Arizona Public Service Company
P.O. BOX 53999 • PHOENIX, ARIZONA 85072-3999

102-02838-WFC/RAB/GEC
February 18, 1994

**Subject: Palo Verde Nuclear Generating Station (PVNGS)
Units 1, 2, and 3
Docket Nos. STN 50-528/529/530
Proposed Amendment to Technical Specification Sections 5.3.1 and 5.6.1,
and New Technical Specification Section 3/4.9.13 and BASES 3/4.9.13
File: 94-005-419.05**

Palo Verde Nuclear Generating Station Updated FSAR
	FUEL STORAGE RACK MODULE ASSEMBLY DETAILS (Sheet 1 of 2)
	Figure 9.1-6

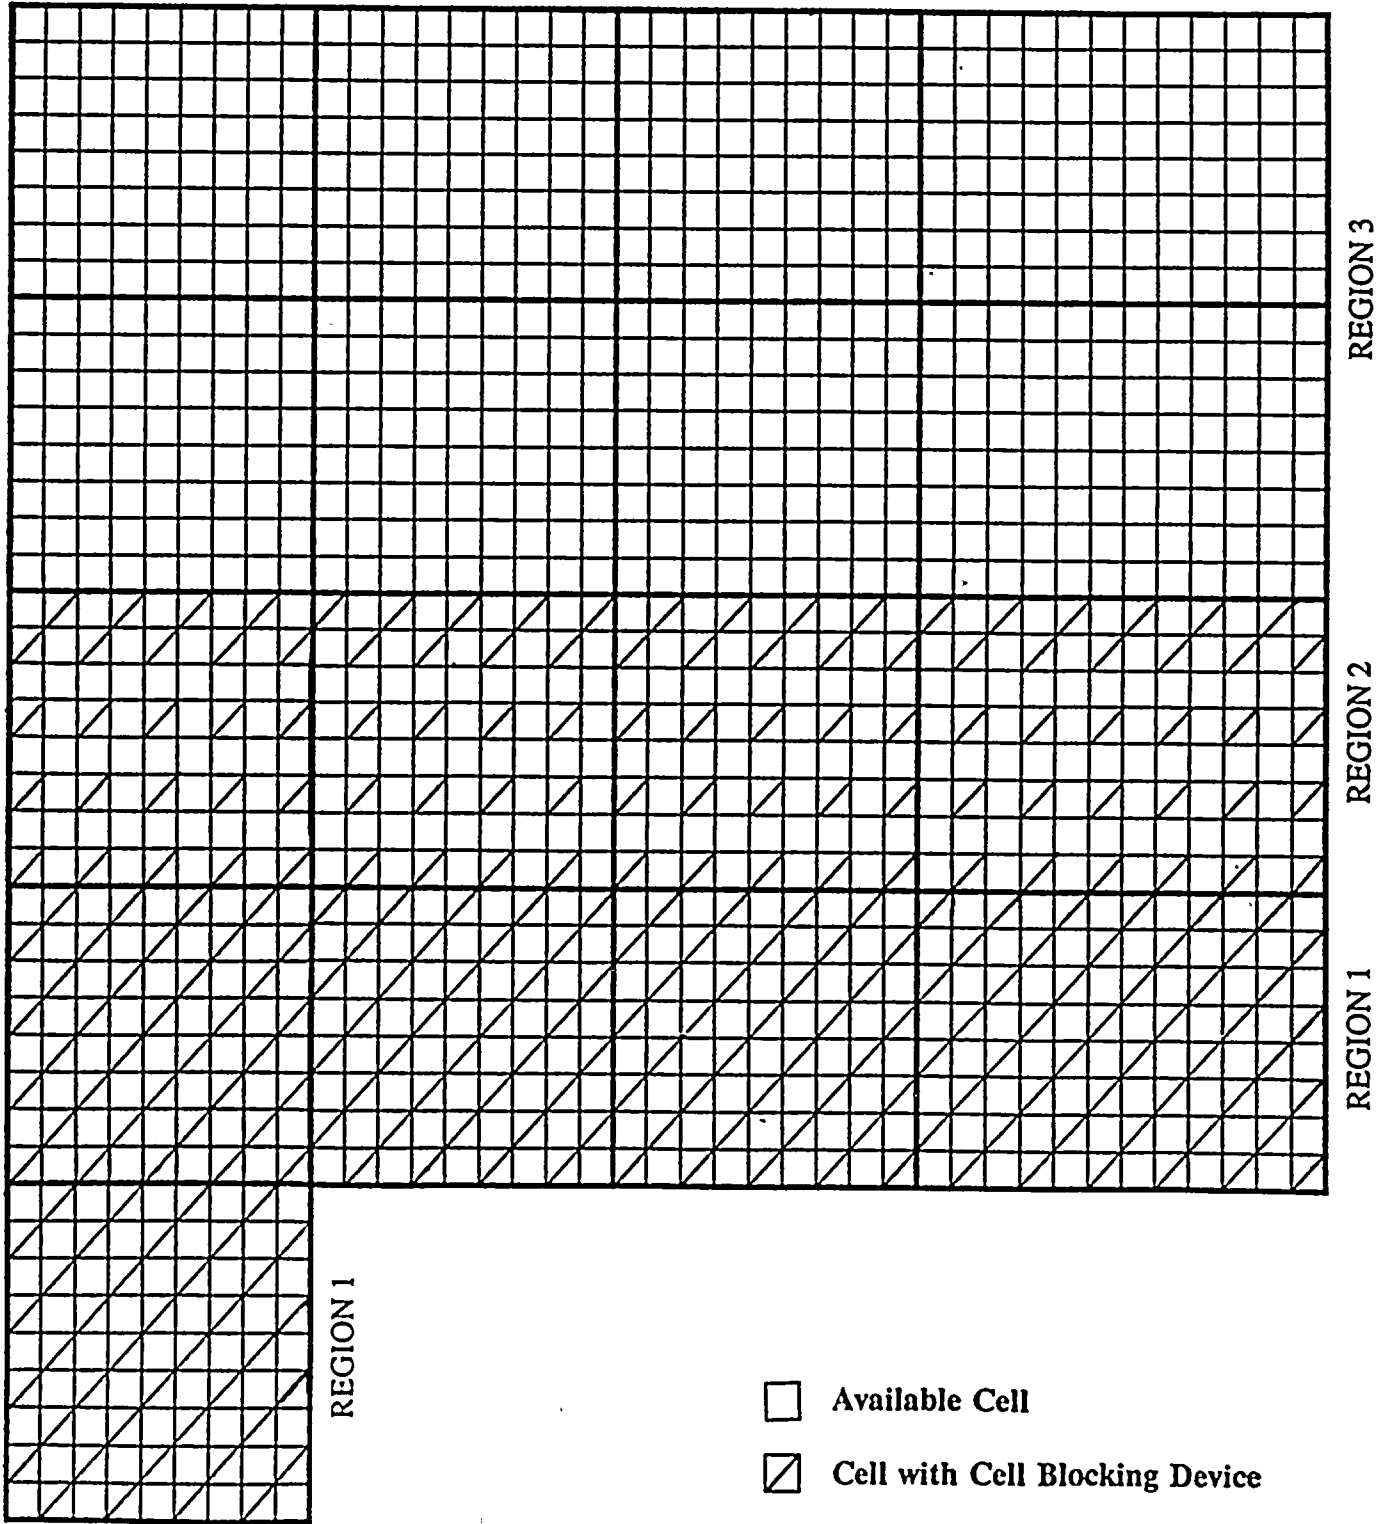
The PVNGS spent fuel storage pool design currently incorporates "L" inserts, as shown in UFSAR Figure 9.1-6 (attached), in two-out-of-four storage rack locations (the "L" inserts are installed in those locations not presently containing cell blocking devices as shown in UFSAR Figure 9.1-5, attached). As part of the plan for increasing available storage in the spent fuel storage pool, APS will not install "L" inserts in the cells where "L" inserts are not presently installed. The safety analysis described in Section D, below, accounts for the "L" inserts presently not installed. In addition, a seismic analysis was performed which concluded that fuel rack stresses, embedment loads, and storage rack mounting pad stresses are

FIGURE 1
Proposed Spent Fuel Pool Configuration

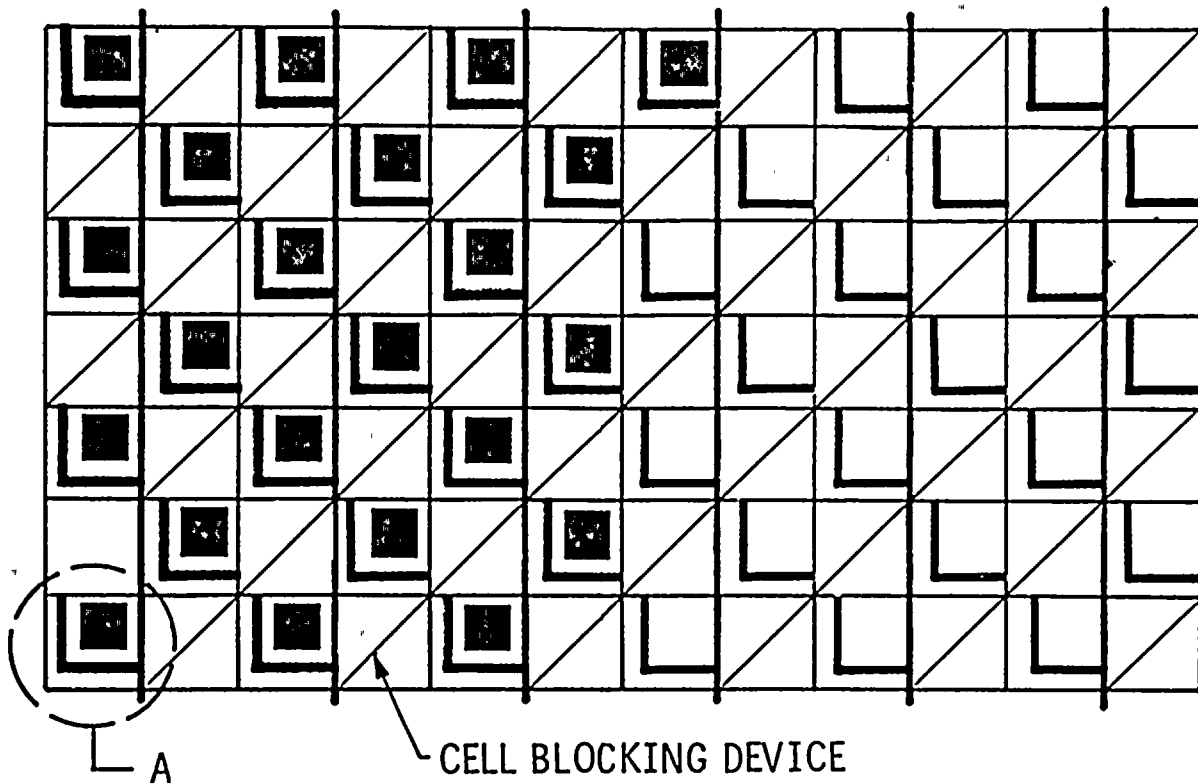
Figure 1 identifies the proposed three region configuration for the PVNGS spent fuel storage pool. Region 1 is comprised of three 9X8 storage racks, one 12X8 storage rack, and one 9X9 storage rack with cell blocking devices already in place in every other storage rack location. Region 2 is comprised of three 9X8 storage racks and one 12X8 storage rack. Cell blocking devices are primarily employed in Region 2 in one out of every four storage rack locations. Additional cell blocking devices are employed in Region 2 along the interface with Region 3, in every other storage rack location, to eliminate the possibility of having an unanalyzed arrangement of assemblies. Figure 1 identifies the required cell blocking device configuration for Region 2. Region 3 is comprised of six 9X8 storage racks and two 12X8 storage racks, and employs no cell blocking devices.

Figure 1 illustrates the proposed three region configuration for the PVNGS spent fuel storage pools. The racks in Region 1 of the pools will be used to store spent fuel assemblies in a two-out-of-four storage configuration. A cell blocking device (shown in USFAR Figure 9.1-6, Sheet 1 of 2, attached) will be used in two of every four storage cell locations. The racks in Region 2 of the pools will be used to store spent fuel assemblies in a three-out-of-four storage configuration. A cell blocking device (shown in USFAR Figure 9.1-6, Sheet 1 of 2, attached) will be used in one of every four storage cell locations (with additional cell blocking devices along the interface with Region 3 to eliminate the possibility of having an unanalyzed arrangement of assemblies). Region 3 will be used to store spent fuel assemblies in a four-out-of-four storage pattern. No cell blocking devices will be employed in Region 3. The current Region 1 pattern of stainless steel "L" inserts, presently installed as shown in UFSAR Figure 9.5-1 (attached) with a nominal thickness equal to 0.175 inches, will also be employed for both Regions 2 and 3.
